World Forum for Harmonization of Vehicle Regulations

194th session

Proposal for the 04 Series of Amendments to UN Regulation No. 137 (Frontal impact with focus on restraint systems)

Submitted by the Working Party on Passive Safety*

Model A

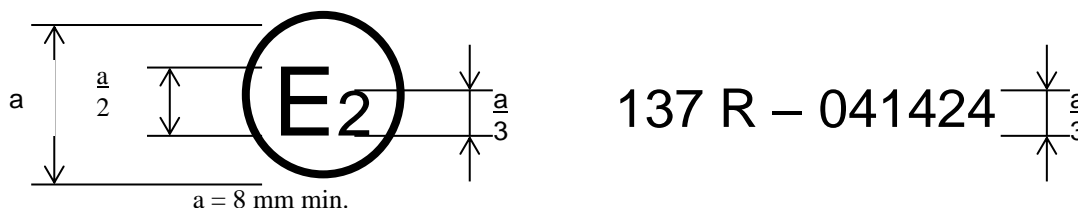
Annex 2, amend to read:

The above approval mark affixed to a vehicle shows that the vehicle type concerned has, with regard to the protection of the occupants in the event of a frontal collision, been approved in France (E 2) pursuant to Regulation No. 137 under approval number 041424. The approval number indicates that the approval was granted in accordance with the requirements of Regulation No. 137 04 series of amendments.

Model B

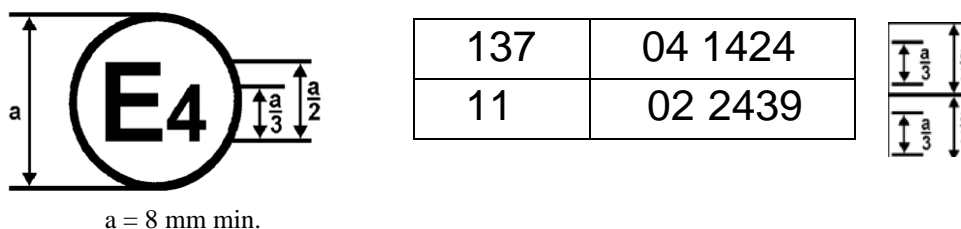
The above approval mark affixed to a vehicle shows that the vehicle type concerned has been approved in the Netherlands (E 4) pursuant to Regulations Nos. 137 and 11.¹ The first two digits of the approval numbers indicate that, at the dates when the respective approvals were granted, Regulation No. 137 incorporated the 04 series of amendments and Regulation No. 11 incorporated the 02 series of amendments."
